**ADDENDUM NO. 2**

Date of Addendum: February 7, 2023

Project Name: Gaston County Schools – Grier Middle School

- A. Owner: Gaston County Schools
- B. Architect: LS3P
- C. Architect Project Number: 9201-218240

C7.5

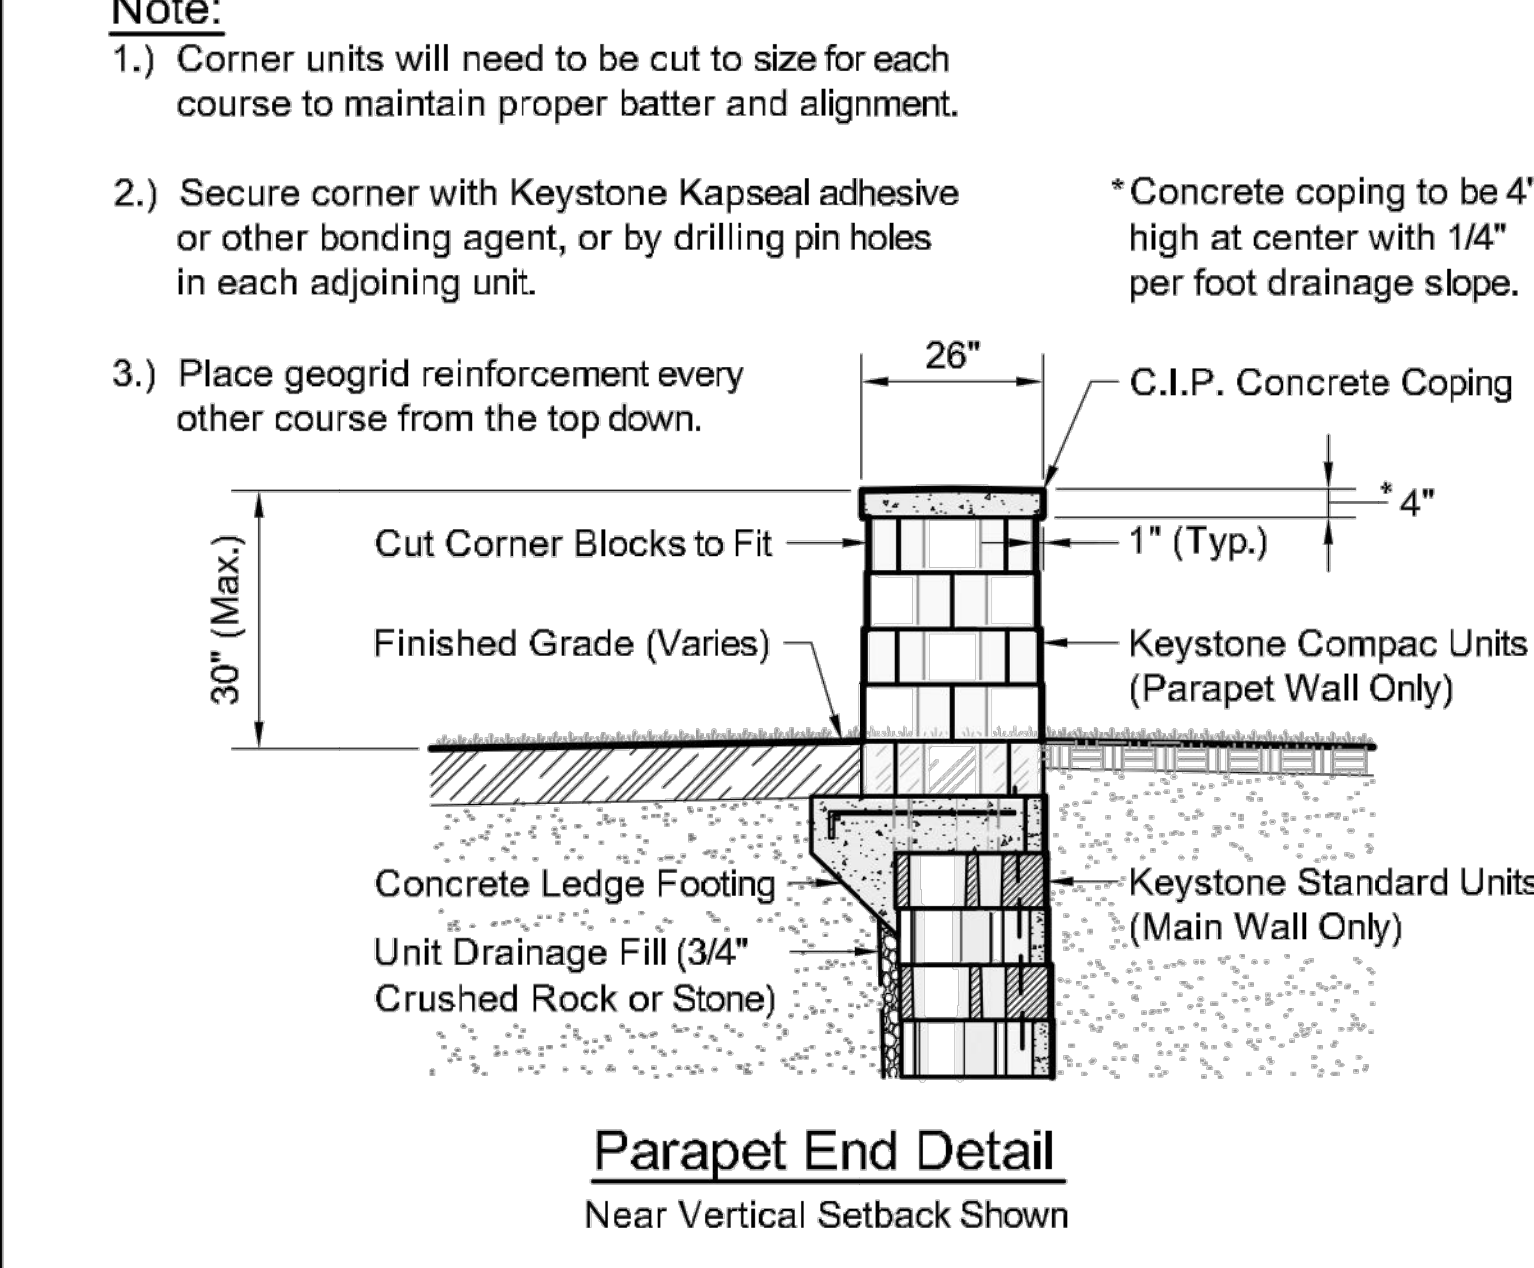
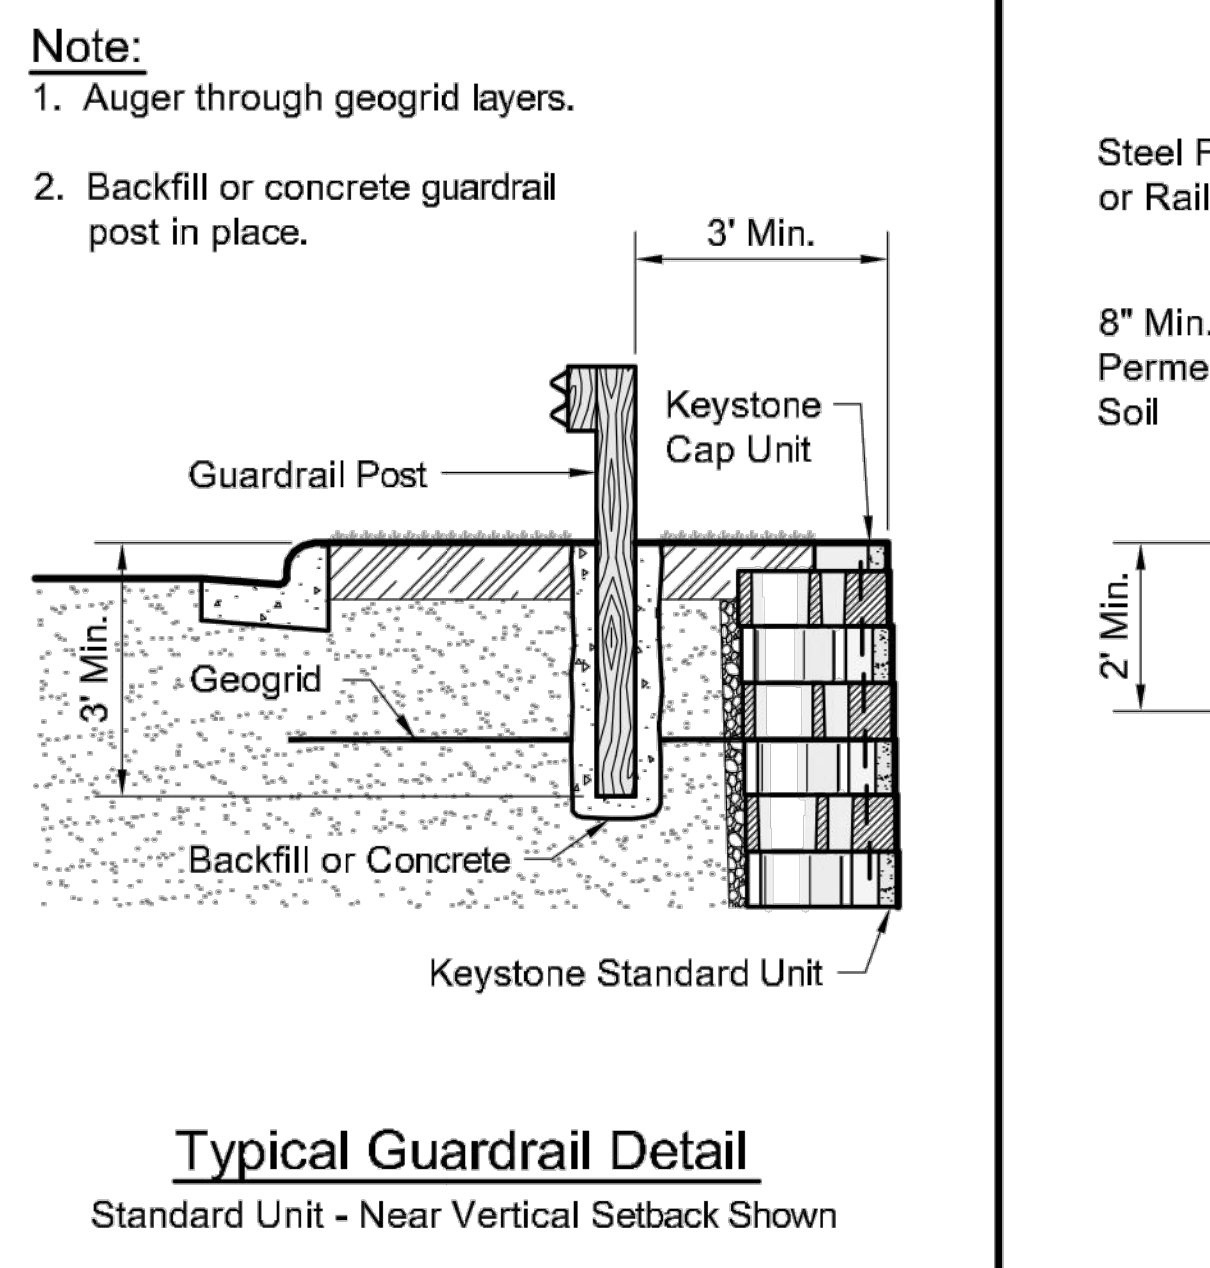
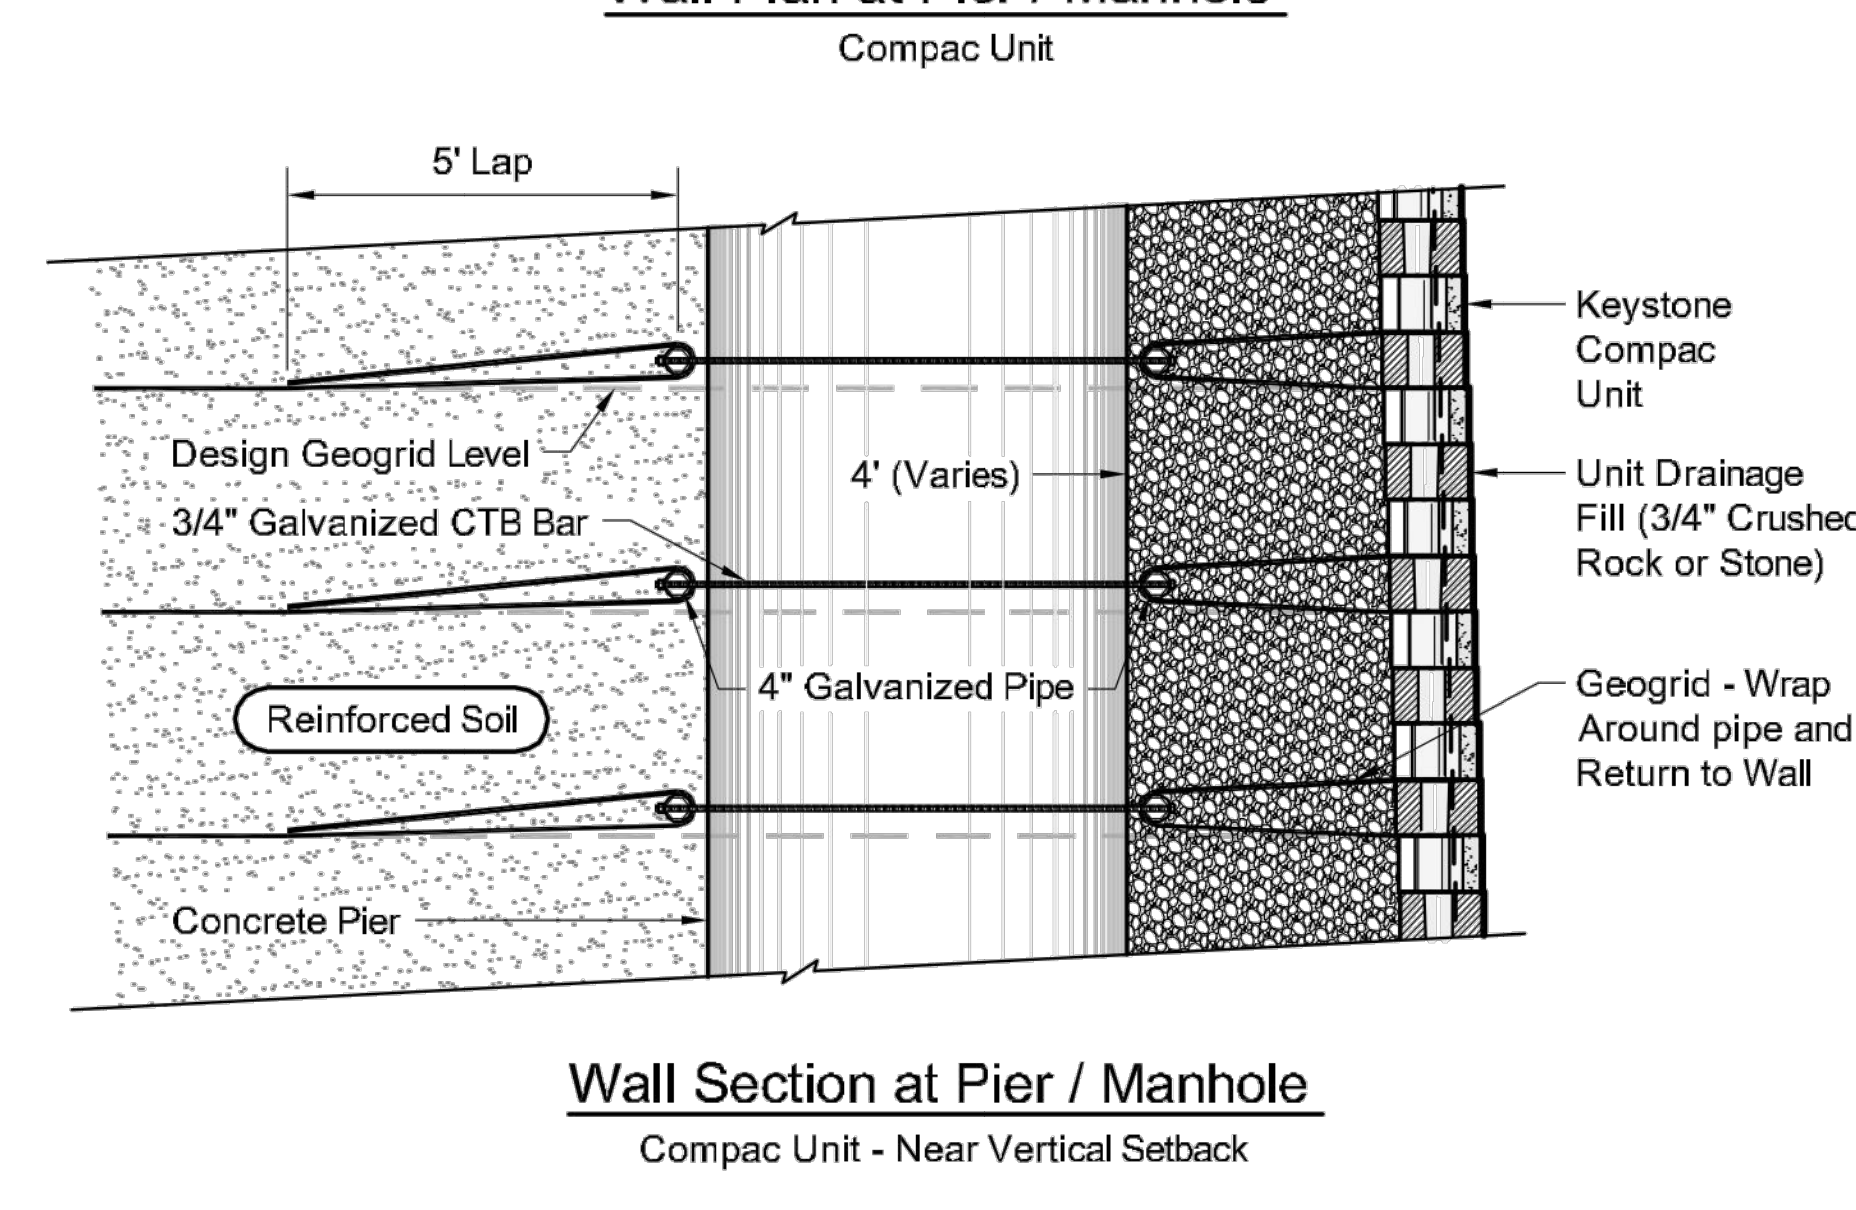
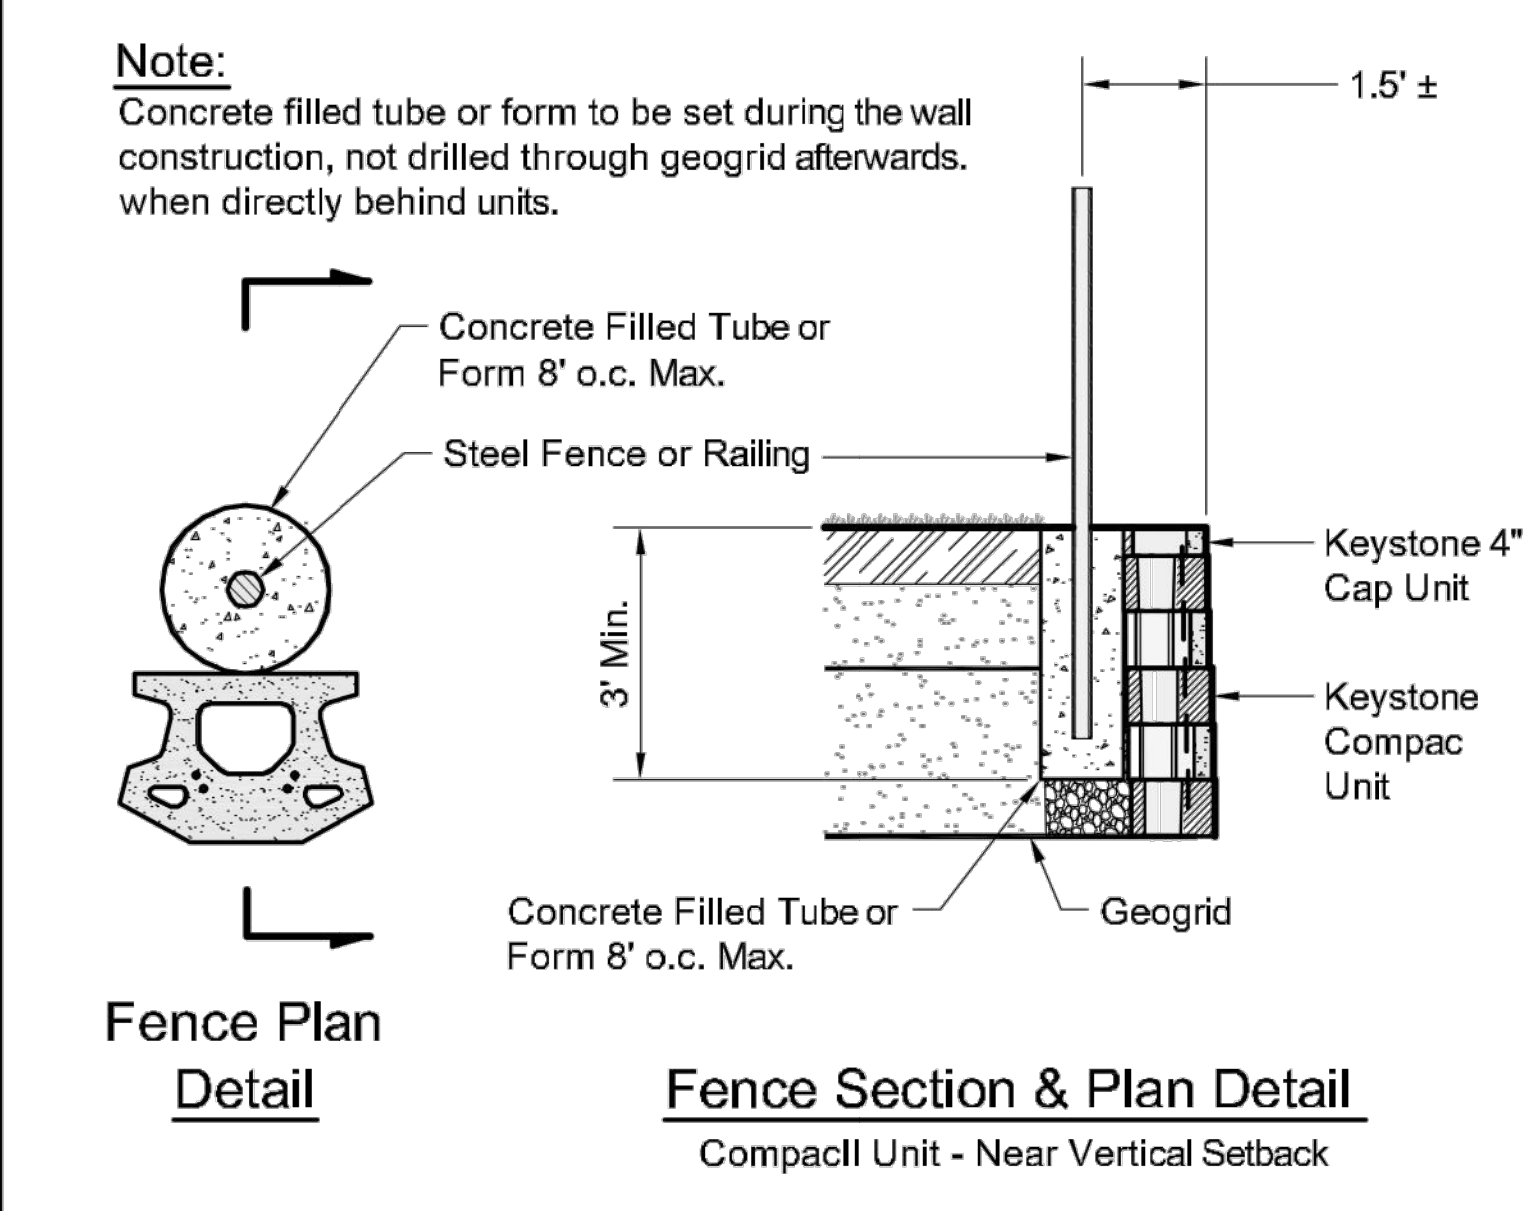
2. Add Detail #9, 35' Flag Pole.
  - L. Add SHEET C7.5 – SITE DETAILS, included in the attachments.
    1. Typical retaining wall details for reference only.
